Grandview Parkway Letter of Understanding

CHRIS ZULL, PE – TRANSPORTATION PRACTICE LEADER, PROGRESSIVE AE

5-2-22 CITY COMMISSION FEEDBACK

CURB TO CURB MAP

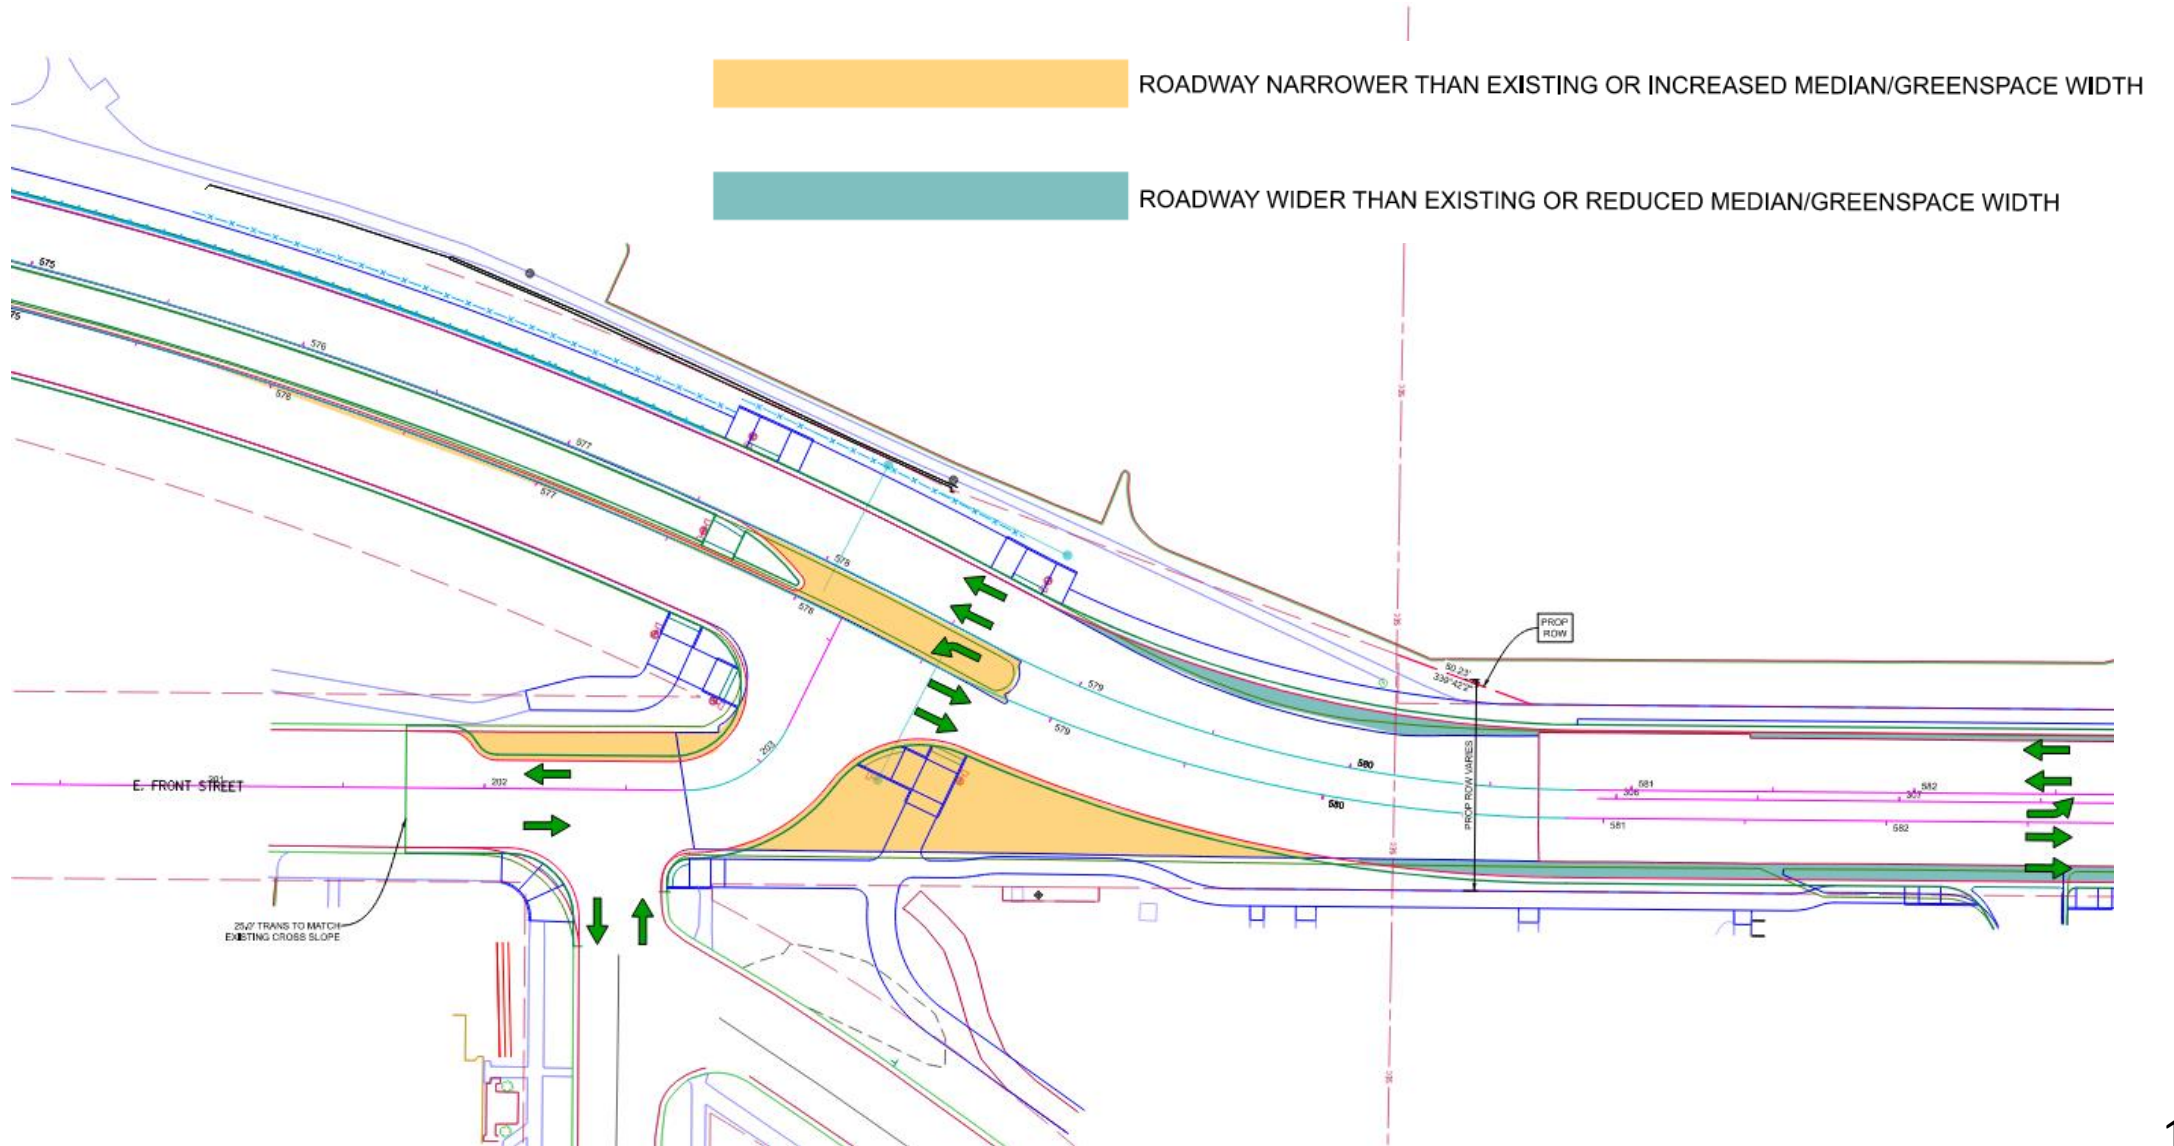
- Design Exception – Lane Width
 - MDOT reports that the design exception for this project is to be approved at the region level and all indications are that this will be approved
- Curb to Curb map
- Radius of WB Grandview Parkway at Front Street
- HAWK Installation Cost
 - Estimated \$60-100K
- Garfield Intersection
- Division Total Crossing Distance
- Stormwater Maps

TOTAL PROJECT PAVEMENT IMPACTS

- Paved travel way **increase:** **19,210 sft**
- Paved travel way **decrease:** **30,210 sft**
- Total **decrease:** **11,000 sft**
